Famkam Printing Ltd.

9th November 2021

Famkam Printing Building (G+2)

Foundation Layout

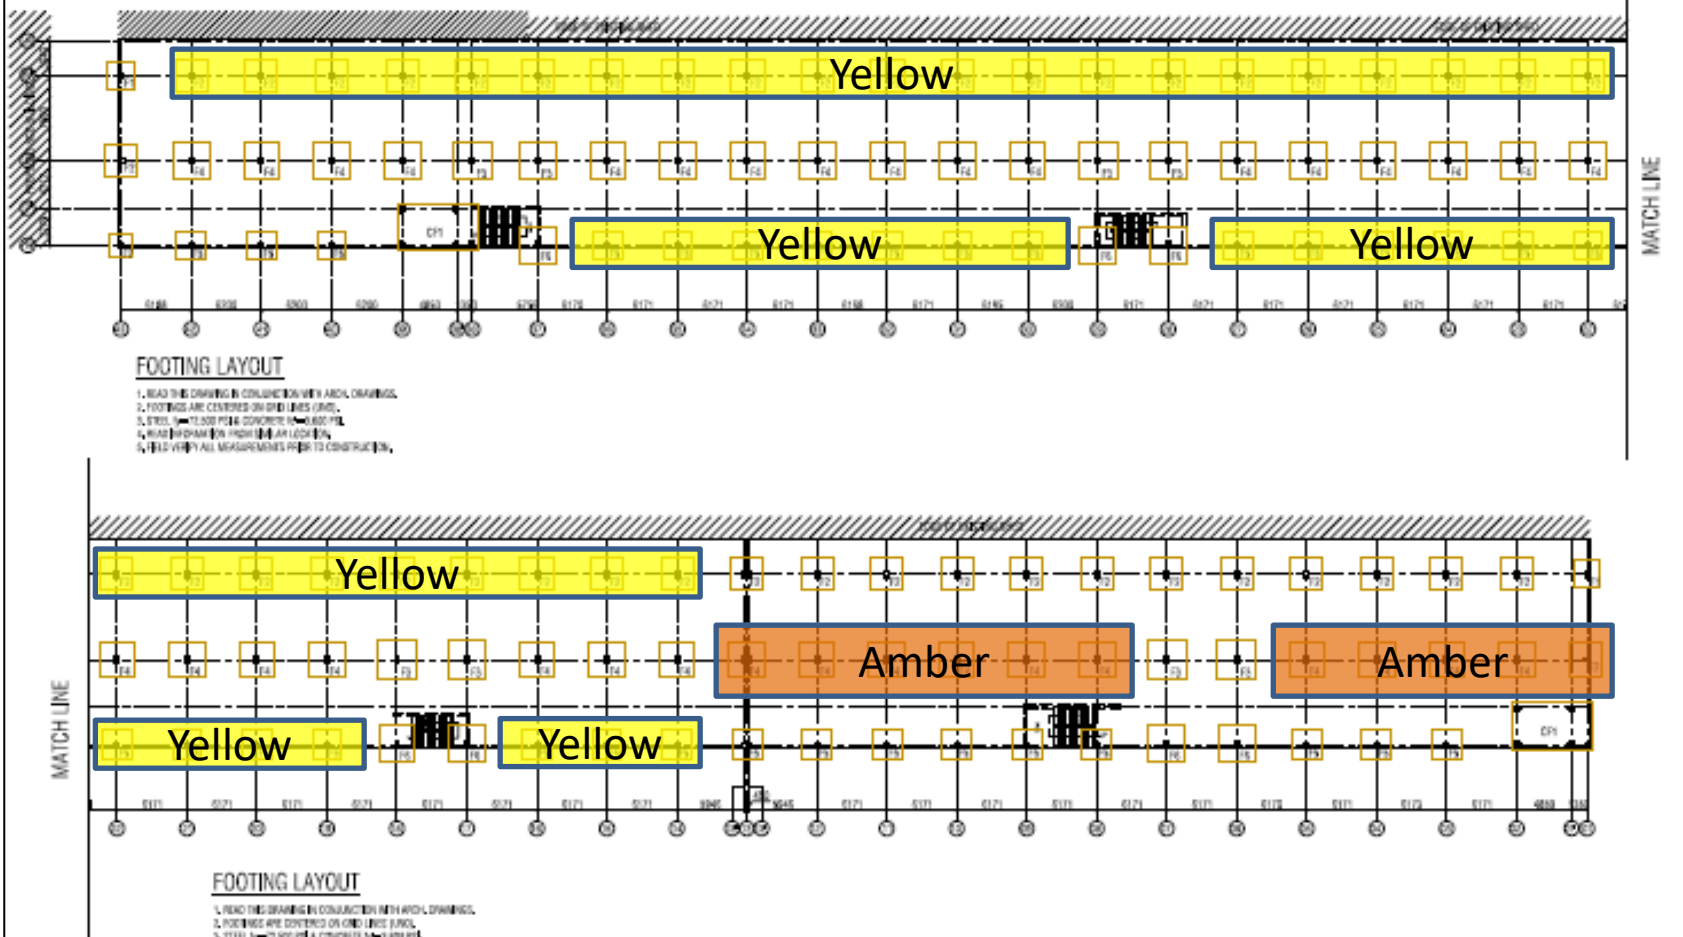
High stress level in foundation that require immediate review

Cursory calculation indicates as below:

- 1) Stress in foundation exceeds normal design limit for the yellow marked location.
- 2) High stress level in foundation that require immediate review for the amber marked location.

Stressed footing in schedule

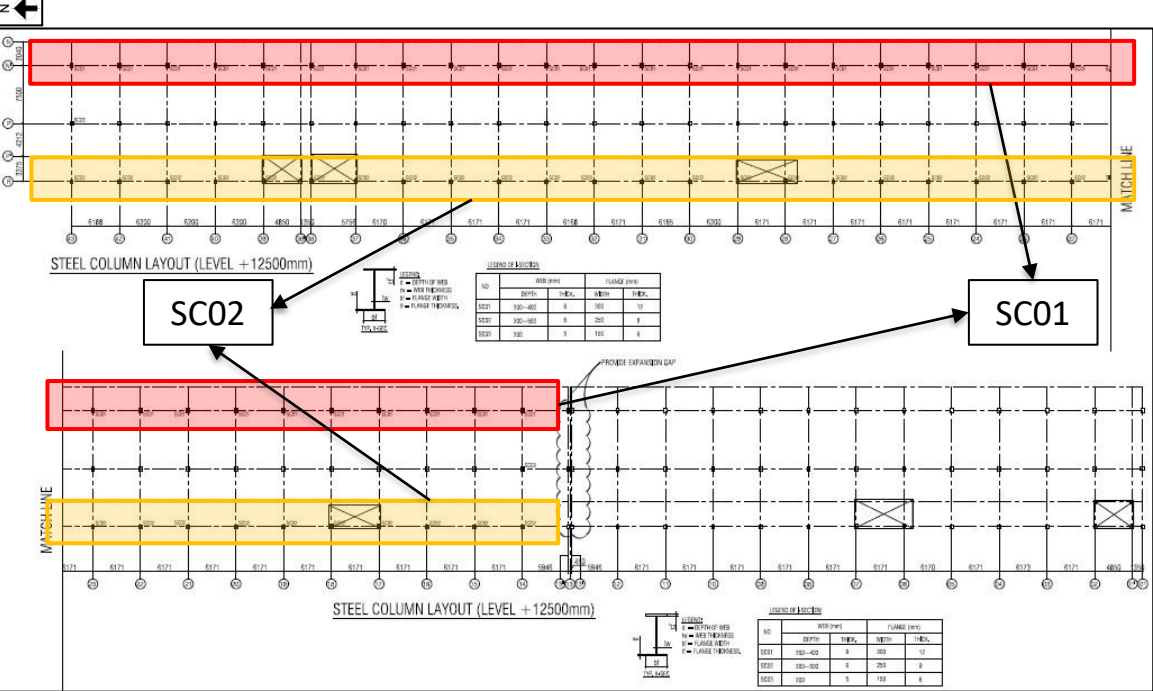
Cursory calculation indicates that High stress level in foundation at highlighted area (amber marked) of previous slide that required immediate design review. Considering 3 kPa live load on typical floor (As per provided load plan) & 1.5 kPa live load on roof these footings have been found high stressed against the soil bearing capacity available from Geotechnical investigation report. Building engineer is immediately required to carryout Detail Engineering Assessment (DEA) for the highlighted areas and submit to RSC for review.

Column Schedule

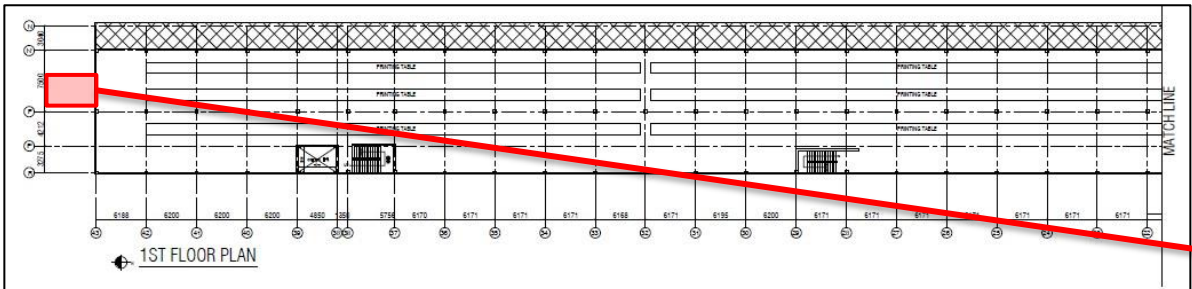
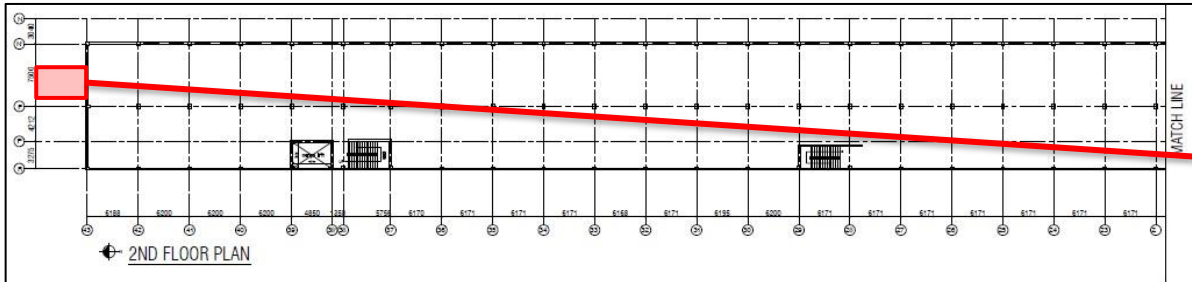
Size measured – Flange width: 250mm & Flange Thickness: 8mm

In as-built drawing, for the SC01 column; flange size 300 mm and flange thickness 12mm has been shown. During inspection, flange width was found 250mm and flange thickness was found 8mm. Building engineer is required to update the as-built drawing with the accurate on-site condition.

Floor Layout

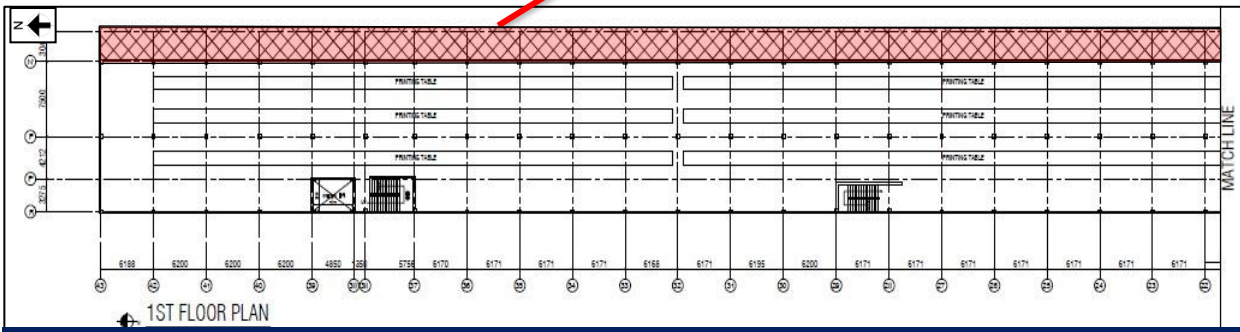
The connecting bridge was found connected with RC beam of the Famkam printing building.

Undocumented steel connecting bridge was found. Building engineer is required to update the as-built drawing with the accurate on-site condition.

Lack of water proofing on roof slab

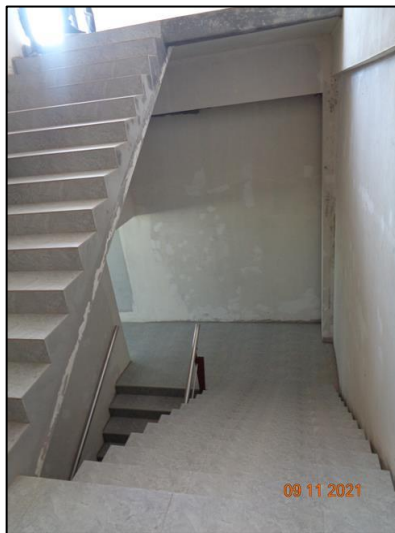
The roof of the building is made of MCAC aggregate but no protective sealing is provided. Provide a protective coating on the structural elements constructed with MCAC exposed to rainfall or other sources of water. Factory is required to provide protective coating with 2% slope on the exposed surface to prevent the accumulation of water.

Connection gap and bolt missing at several location

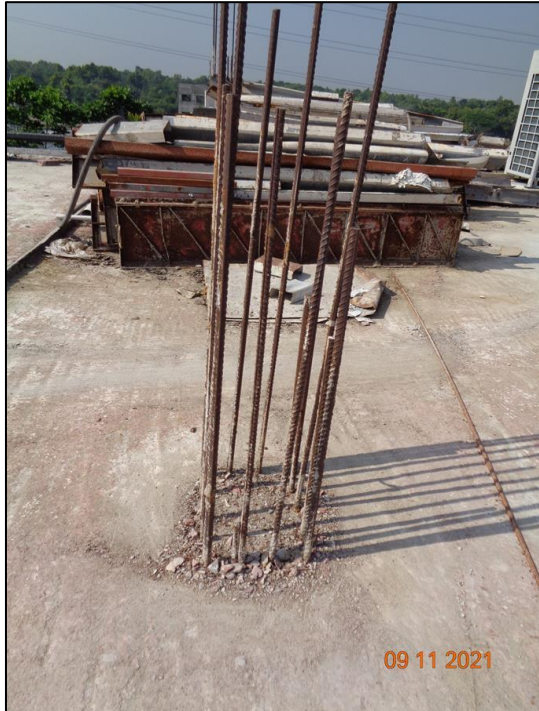
Connection gap was found in rafter-rafter & rafter-column connection

Bolt missing in Beam-column connection at ground floor

Connection gaps and missing bolts observed at column rafter joint at several location. Factory engineer is required to identify the locations and carry out suitable remedial works.
